CERTIFICATE OF APPROPRIATENESS PLACARD

15 E MARTIN STREET

MOORE SQUARE

From: Mike Morrison <mike@maurerarchitecture.com>
Sent: Tuesday, January 24, 2017 1:28 PM
To: Tully, Tania
Subject: Re: Minor Work COA - 15 E Martin Street
Attachments: 003-17-CA (15 E Martin Street) - Muntins.pdf; 003-17-CA (15 E Martin Street) - Local Window 4-4 Examples.pdf

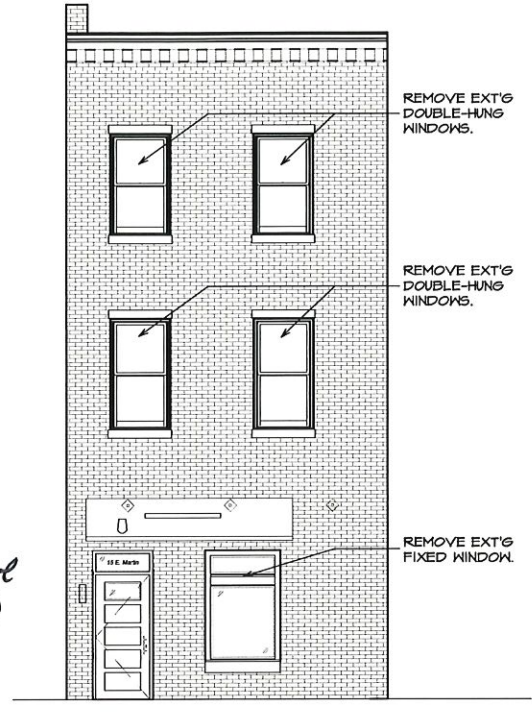
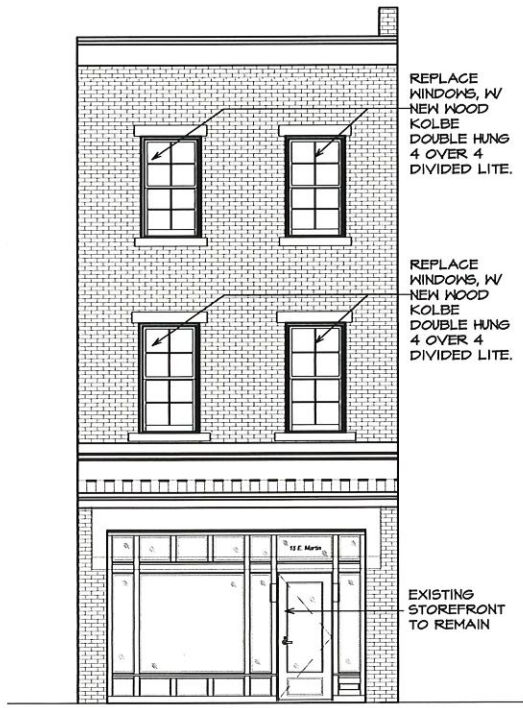
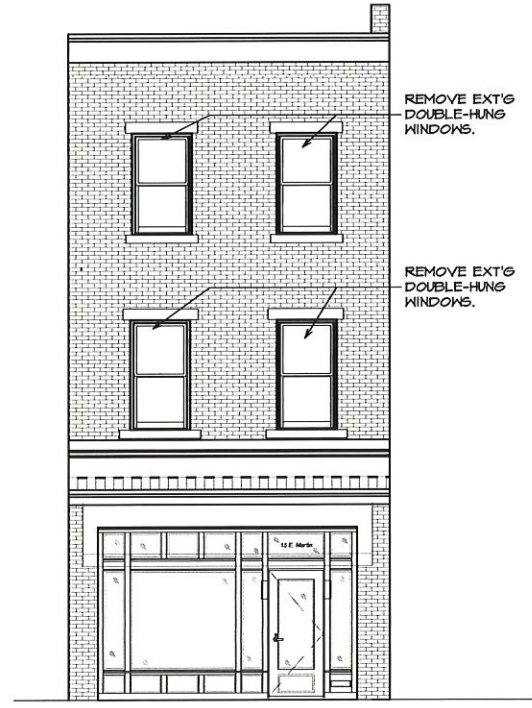
1. Please provide photos of other 4/4 windows in Moore Square. I think the Busy Bee has them.
2. The proportion of the panes appear to be square and/or almost horizontal. Is this accurate?
3. You propose a 1-1/8" wide muntin. A 7/8" muntin is more traditional for 4/4 sash.
4. The section drawing of the muntin is for a metal window and somewhat hard to read. It makes it appear as though the external muntin is not really external. Please submit a better drawing.
5. The proportions of the panes on the rear lower window are horizontal and out-of-character for the building and district. I suggest either leaving what is there or proposing a different light pattern.

Regarding the window muntin section property. I have attached a new detail, it will be the 7/8" muntin, beveled exterior with the ogee profile interior. I am proposing that the first floor window remain as is without muntins.

Regarding the window divisions, I believe there was a discrepancy in some of the original dimensions. It is my belief that the lites will be close to square for the shorter windows. My initial calcs show the lites to be 1'4.5 wide x 1'3.5 high. The taller upper window lite proportion will be vertical.
